Subject: Re: AGATA Crystal positions (Look-Up Table)

Posted by [thuyuk](#) on Tue, 24 Mar 2015 10:17:38 GMT

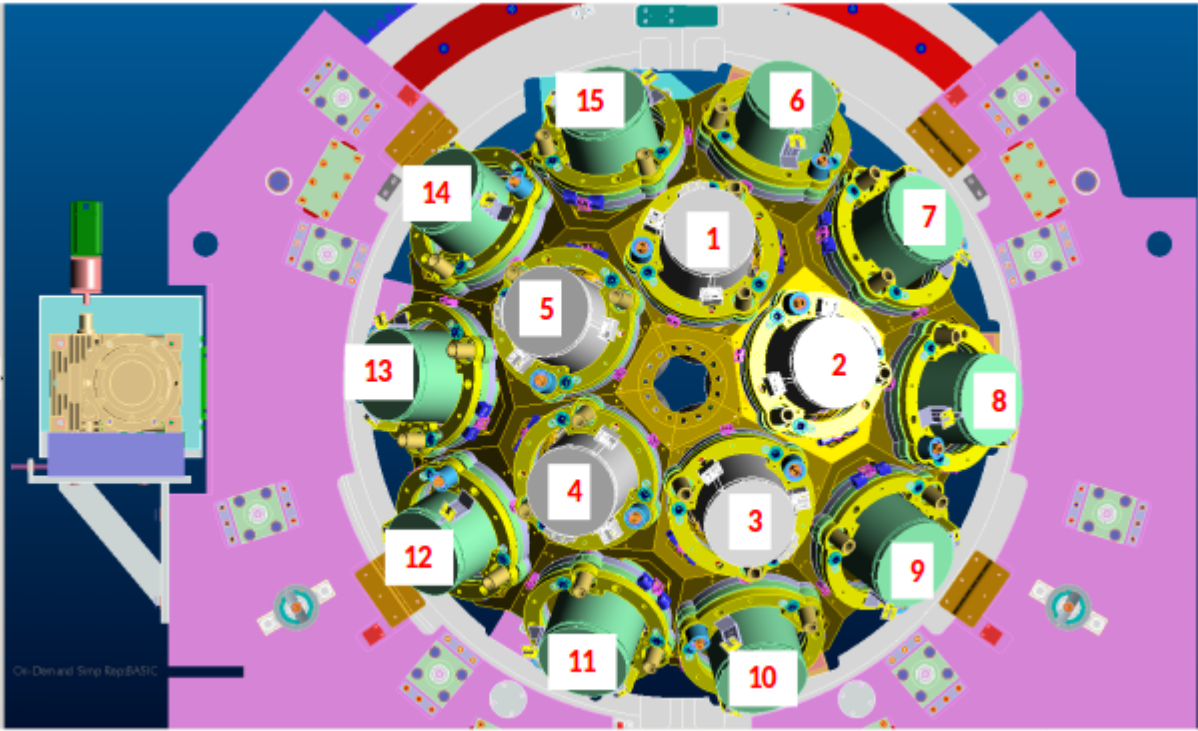
I just found another drawing that Damian sent to me in our private communication. The positioning of the AGATA detectors there also suggest that we should swap the horizontal axis. I didn't get the permission from Damian, but I think he will be OK that I put the image below:

1) [agata-report.png](#), downloaded 1540 times

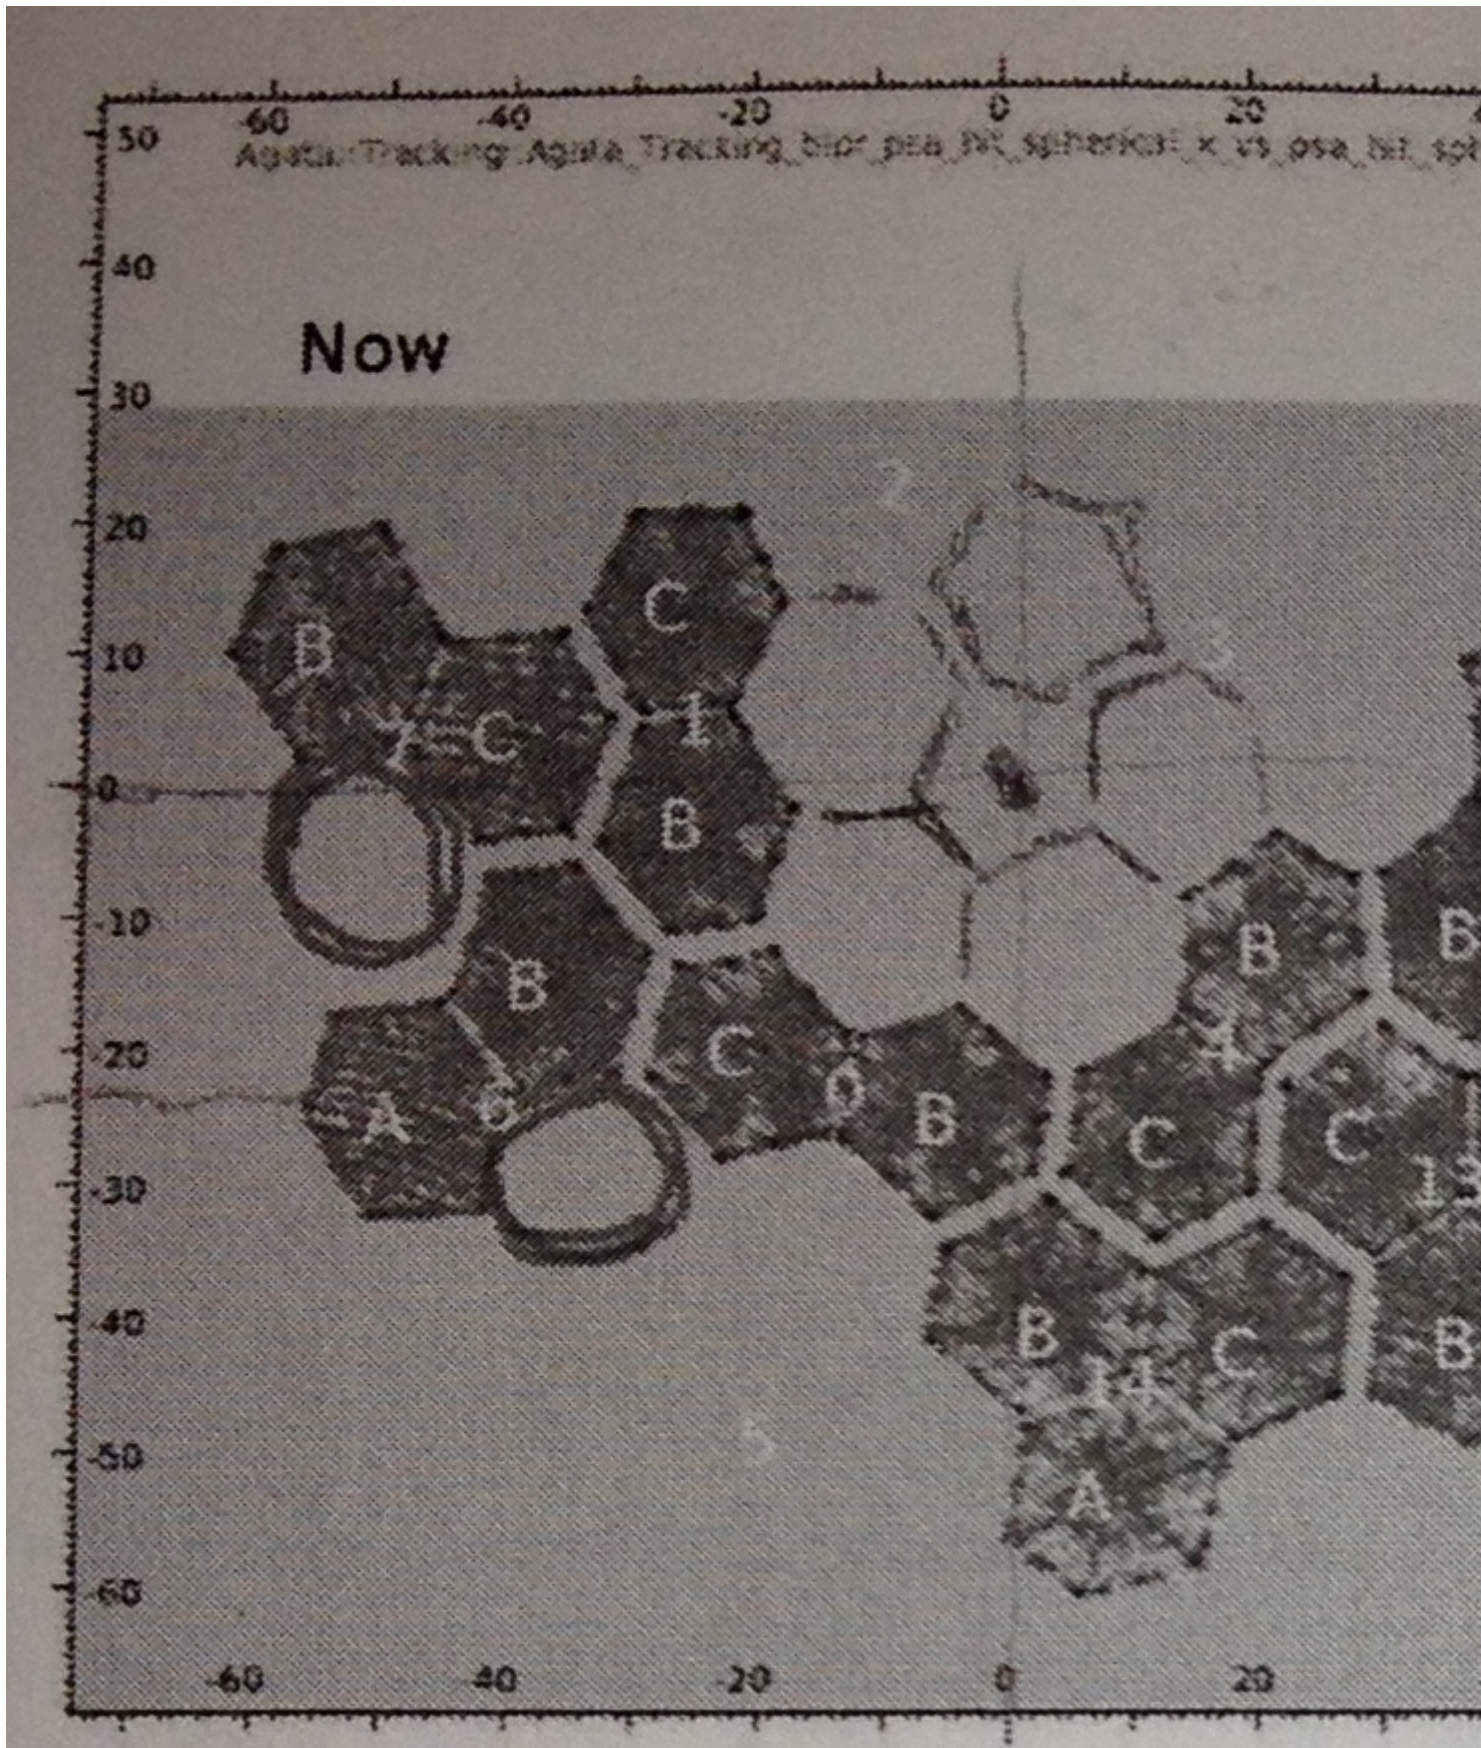
After looking at the drawings that Damian did, and compare them with what I get with the current CAD-lookup table, I see that the whole array suppose to be swapped in the horizontal axis.

These are the positions in the measurement report that Oliver sent:

My point is that the cryostat number 1 in the second image does not correspond to the cryostat number 5 in the measurement report, but it seems to me that it corresponds to number 2.

My idea is supported by looking at the number 4 and number 12 in the second image that they have a touching edge, but number 3 and 8 don't have a touching edge in the image that is inside the measurement report. Is it true what I'm saying?
